Lynx Distributor – false fuse blown alarm

Technote January 2023 – v2

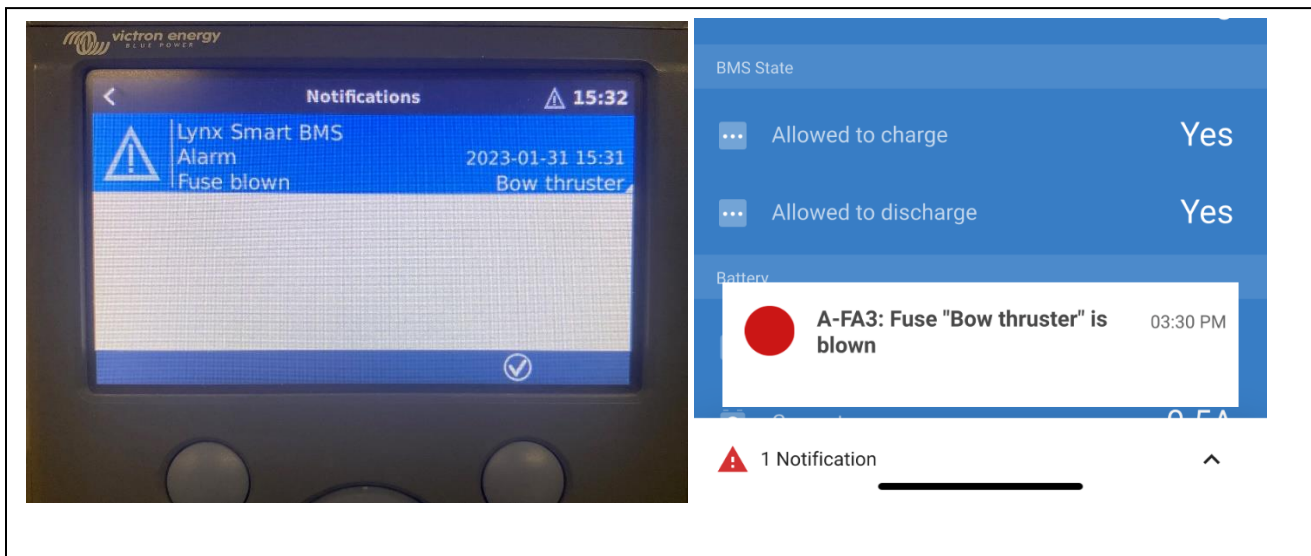
The issue happens mostly with fuse 3, but is also seen on the other fuses.

Below screenshots show how the alarm looks on a GX device as well as in the VictronConnect app.

As a work-around, disable fuse monitoring. This is done using the VictronConnect app: log in to the Lynx Smart BMS, go to Settings and there at the bottom disable the fuse reporting for the fuse that gives the problem.

Detail 1

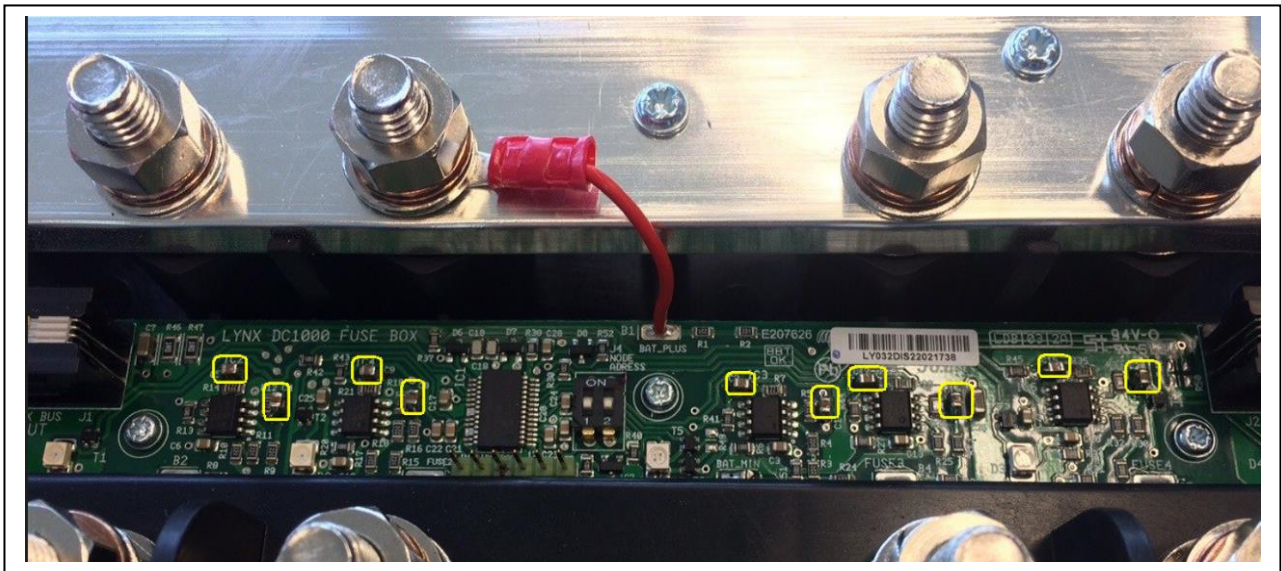
There was an error in the hardware design of the Lynx Distributor that can cause it to falsely report a blown fuse: a fuse blown alarm is raised while the fuse is OK and connected circuit is powered.

Change C1/C2, C4/C5, C8/C9, C11/C12, C14/C15, must become 0805 MLCC X7R value 10uF-10V/16V

Suitable parts are Murata: GRM21BR71A106KA73K, Samsung: CL21B106K0QNNNE/CL21B106KPQNNNE, Yageo: CC0805KKX7R7BB106 or CC0805KFX7R6BB106

After modification, a conformal coating, such as HumiSeal, is to be applied on the newly placed components to protect them from the environmental factors they are exposed to. Assure to protect any critical electrical contacts such as connectors against the lacquer as it will create malfunctions.
